**Modification/Change Order No. 3 Rev.1**

EWP – Cane Island Branch of Buffalo Bayou Channel Bank Stabilization Phase V

Fort Bend County, Texas

December 18, 2020

PLAN VIEW - SITE 113D

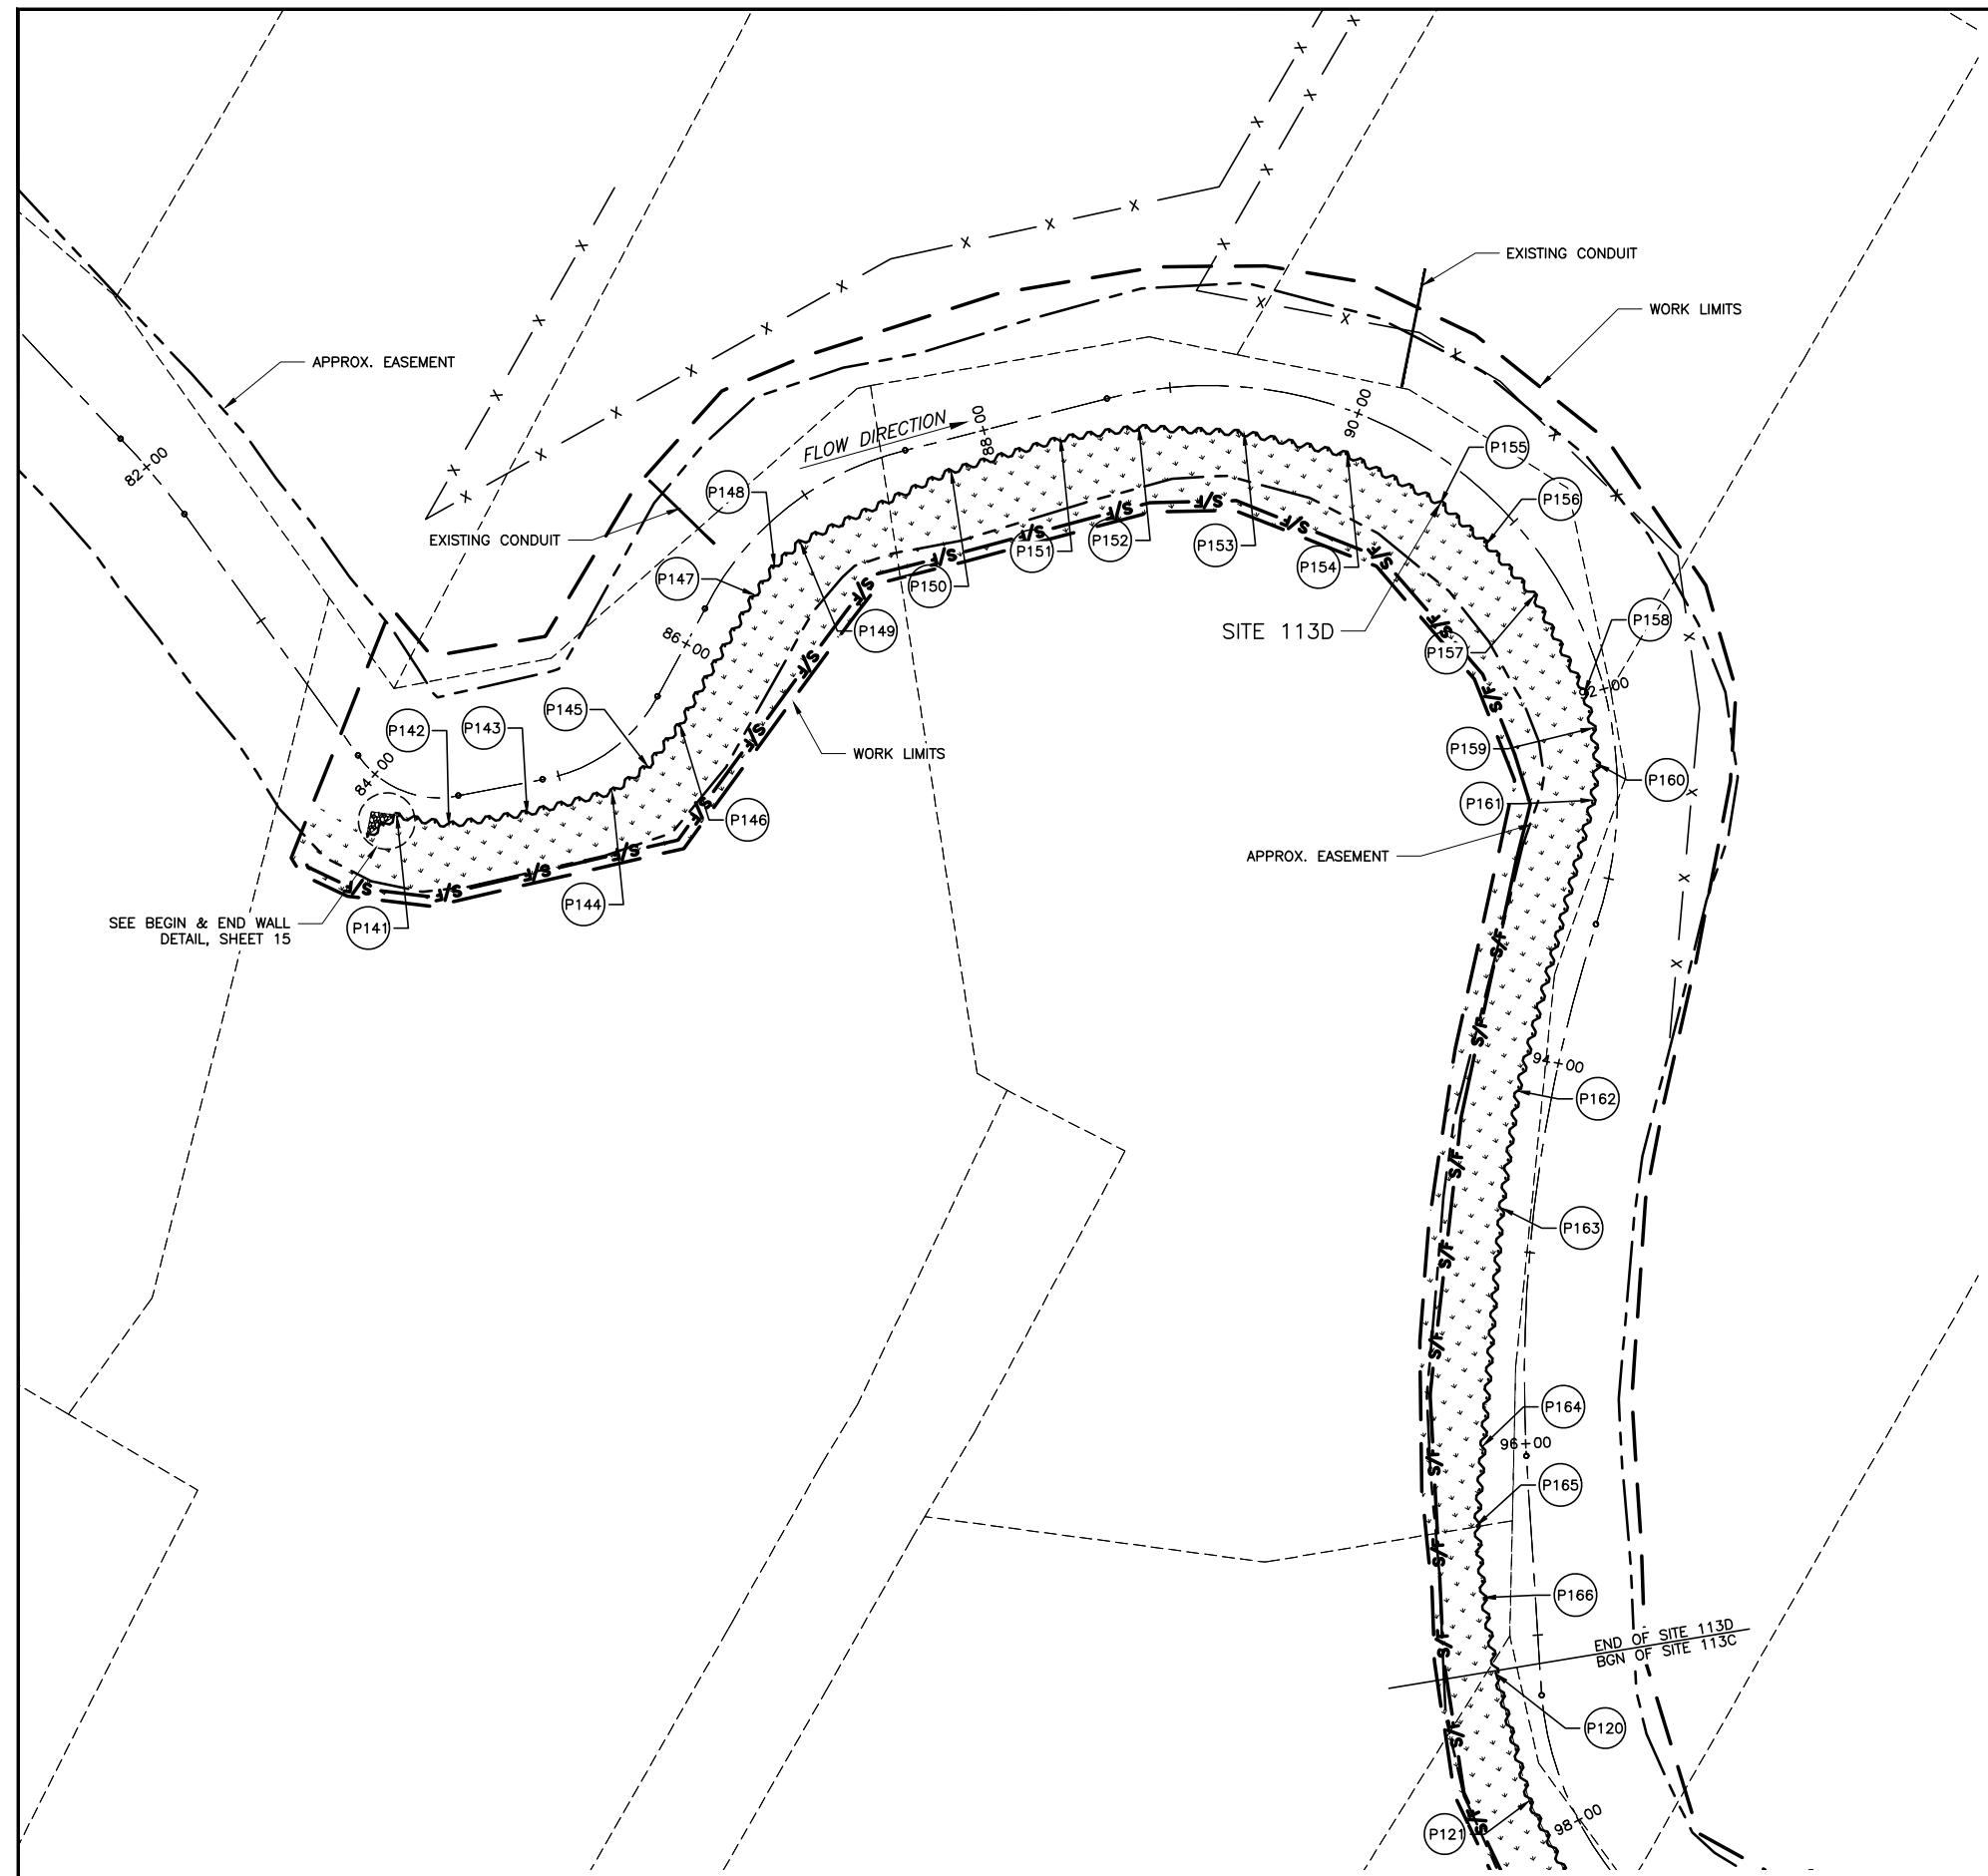
1. Site 113D shall be constructed in accordance with the modified Drawing Sheet No. 2 attached. Site 113C shall be constructed in accordance with the attached drawing at the intersection of Site 113D and Site 113C. Subsidiary items; Anchor, Jet Filters and Waler shall be installed as specified in the contract specifications. Drainfill shall be installed as specified in the plans. Site Preparation shall be added in conjunction with the change, all required excavations and earthfill
2. Compensation for added anchors extensions for the Steel Sheet Pile walls shall be added as specified below.

Wall Extension

REVISIONS		
DATE	APPROVED	TITLE
12/9/20	BTS	ADDED PILING-SITE 113D
